Groundwater Transfer Review Summary Form

Transfer/PA # T- 14789 RA

Ground Water Review Form:

Application: T-14789 RA

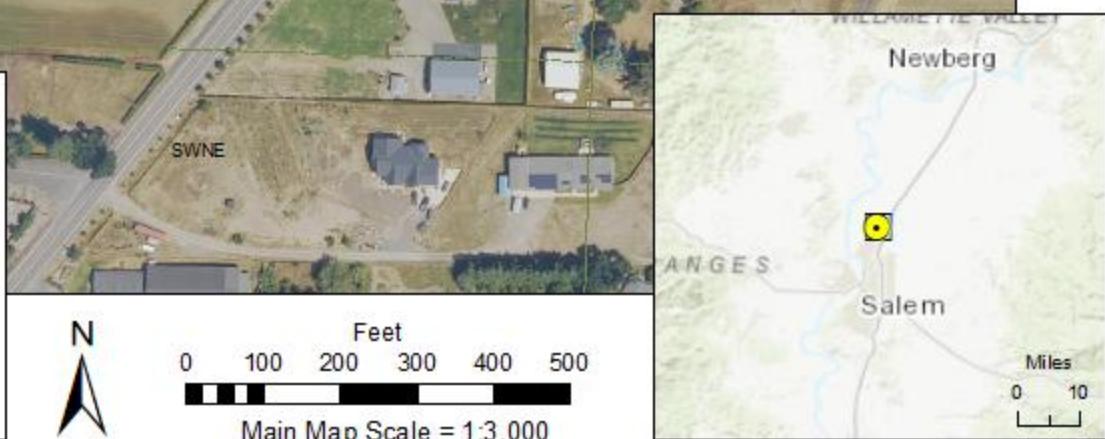
6. a) Will this proposed change, at its maximum allowed rate of use, likely result in an increase in interference with **another surface water source**?
 Yes No Comments: The proposed APOA “Well 4” (MARI 71280) is very close to authorized POA “Well 3” (MARI 68355) and not meaningfully closer to any surface water sources. Therefore, no increase in interference with another groundwater right is likely.
